Wednesday, 1/18/2006 4:04:54 PM. Date: Kim Johnston User: **Process Sheet Drawing Name: BRACKET ASSEMBLY** Customer: CU-DAR001 Dart Helicopters Services Part Number: D3183043 Job Number: 25556D Job Number: Description: Seq. #: **Machine Or Operation:** SECOND CHECK 5.0 Comment: SECOND CHECK Bolt D312121 6.0 2.0000 Each(s)/Unit Total: 8.0000 Each(s) Comment: Qty.: Pick: **Qty Part Number** Description Batch 2 D3121-21 Bolt Bas456 Bearing Assembly 7.0 D3183045 2.0000 Each(s)/Unit Total: 8.0000 Each(s) Comment: Qty.: Pick: Qty Part Number Description Batch B23974 2 D3183-045 Bearing Ass SMALL & MEDIUM FAB RESOURCE 1 8.0 Comment: SMALL & MEDIUM FAB RESOURCE 1 MS 06/02/10 Assemble D3183-043 as per Dwg D3183. INSPECT WORK TO CURRENT STEP QC5 9.0 Comment: INSPECT WORK TO CURRENT STEP PACKAGING RESOURCE #1 PACKAGING 1 10.0 Comment: PACKAGING RESOURCE #1 Identify and Stock Location: 11.0 Comment: DOCUMENT CONTROL Sut 06/02/14 Inspection Level 21 Job Completion

DART AEROSPACE LTD	Work Order:	2556D
Description: Bracket	Part Number:	D3183-3
Inspection Dwg: D3183 Rev: C		Page 1 of 1

FIRST ARTICLE INSPECTION CHECKLIST

DESIGN DRAWN BY CHECKED APPROVED		BY P	DART AEROSPACE LTD HAWKESBURY, ONTAR

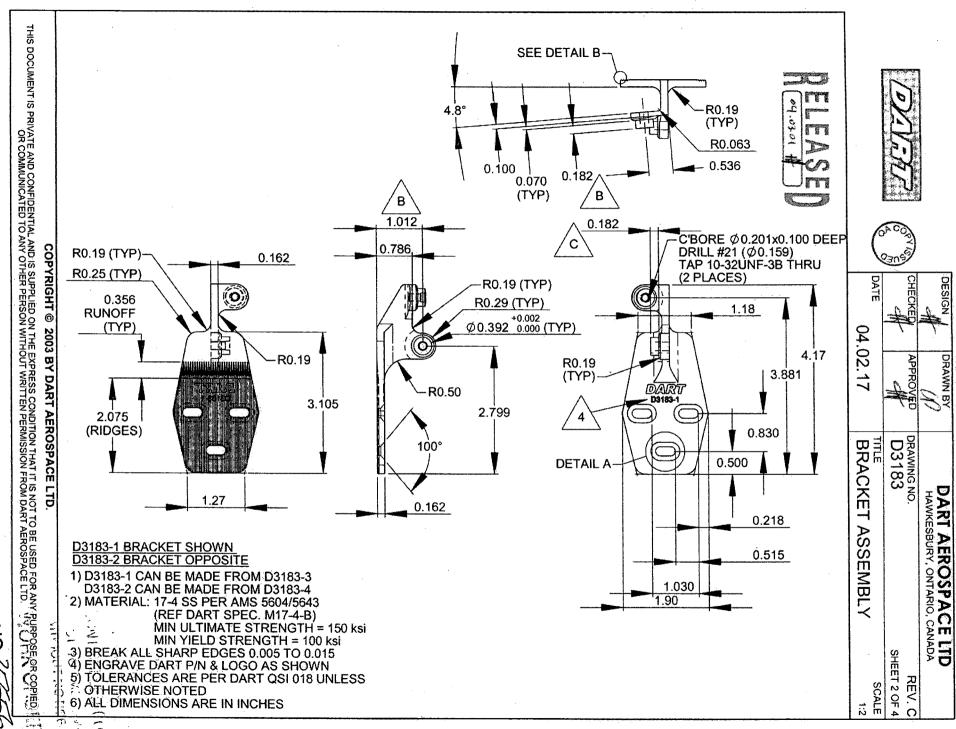
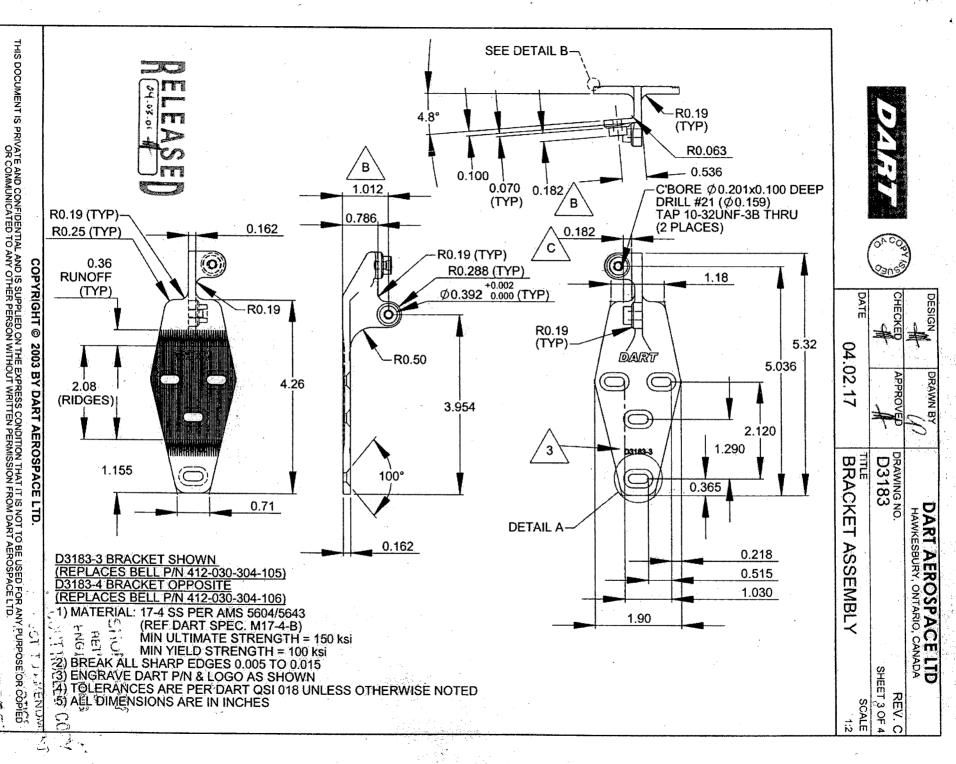
C1 - 1 0 D3121-21 BOLT (1) 04.11.09 0.830 WAS 0.850

D3183-045 BEARING ASSEMBLY

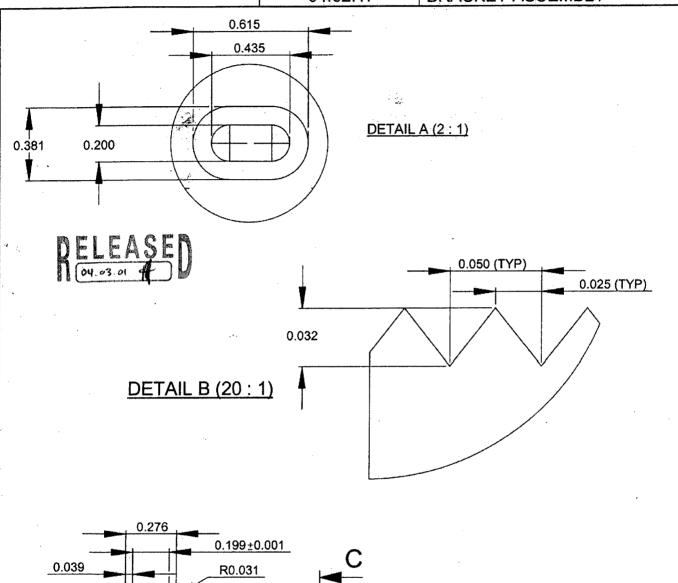
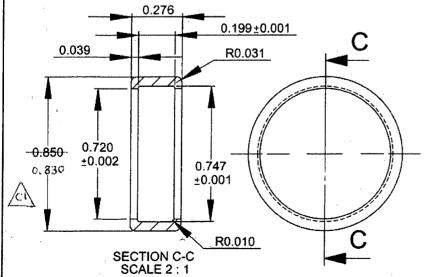
February 10, 2006 1:00 PM Sent: **Chris Provencal** To: Re: D3183-3 Bracket Subject: This is an acceptable deviation. David ---- Original Message -----From: "Chris Provencal" <cprovencal@dartaero.com> To: <davids@dartaero.com> Sent: Friday, February 10, 2006 6:21 AM Subject: FW: D3183-3 Bracket > ----Original Message-----> From: Chris Provencal [mailto:cprovencal@dartaero.com] > Sent: February 9, 2006 3:26 PM > To: 'davids@dartaro.com' > Subject: D3183-3 Bracket > For D3183-3 bracket (roller brackets) > There was a worn out tool, for the slotted holes on one, the height of the > slots should be 0.200, we are measuring 0.215". Is this OK? > Sincerely, > Chris Provencal > DART Aerospace Ltd. > Email..cprovencal@dartaero.com > Phone...613-632-3336 > Fax.....613-632-4443 >
